To: Art Dotson, Building Development Services
From: Randy Lyman, Pretreatment Coordinator
Date: 9/9/2003
Re: Sampling & Observation Manhole-1515 E. Independence

Re: Goodwrench Quick Lube

I am requesting review of a detail for a method of sampling the waste downstream of the exterior oil interceptor serving these floor drains. This request is made because this method varies from the standard Department of Public Works detail for sampling manholes. We do not believe this standard sampling manhole is necessary for this installation with a small potential for oil-containing wastes.

SAMPLING PORT DETAIL

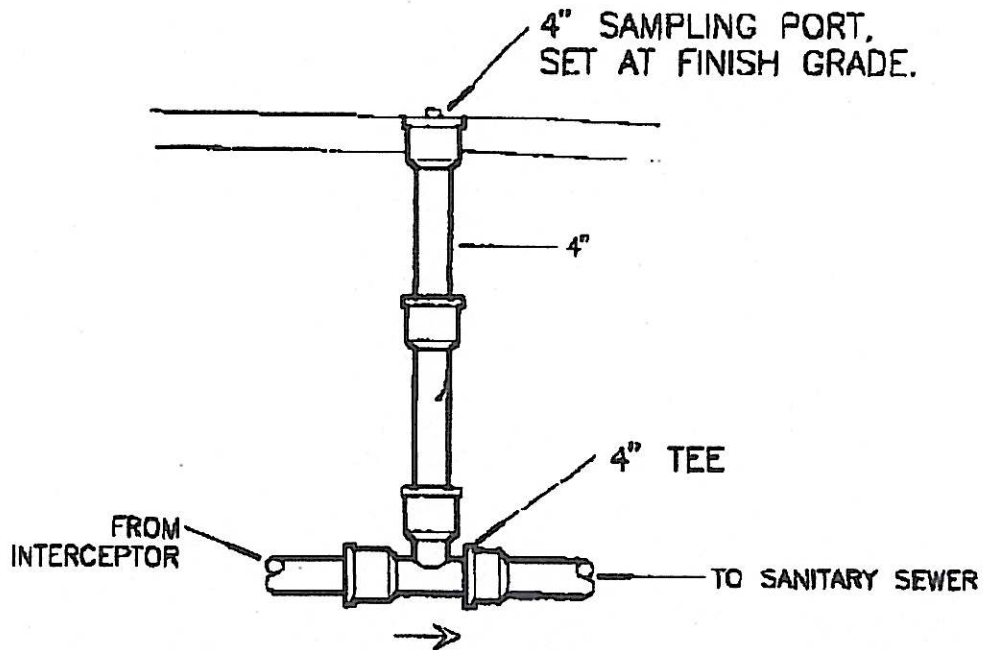
You sent me a copy of a request by Jon Eckhardt of Malone Finkle Eckhardt & Collins seeking a variance from our sampling & observation manhole requirement for facilities like this one, a proposed Goodwrench Quick Lube to be located at 1515 E. Independence, operated by Thompson Sales, I believe. Our reason for having this requirement is to discretely monitor the wastewater discharge from facilities with wet processes other than solely domestic use that could have a potential to discharge prohibited or restricted substances. In looking at the GIS, if they were hooking into a sewer line that would never serve additional connections, we could use the first downstream city manhole as a sampling and observation manhole. But it appears that this parcel may be split and could have other connections to this sewer and we would have to go back on them at a later date and try to get a sampling manhole installed at that time. Based on these findings, a variance from this requirement is not recommended for this facility.

9/3/03 Called Art D. @ 1074 and said there should already be a sampling manhole out the entire facility, if not, we need one "there", not "here".
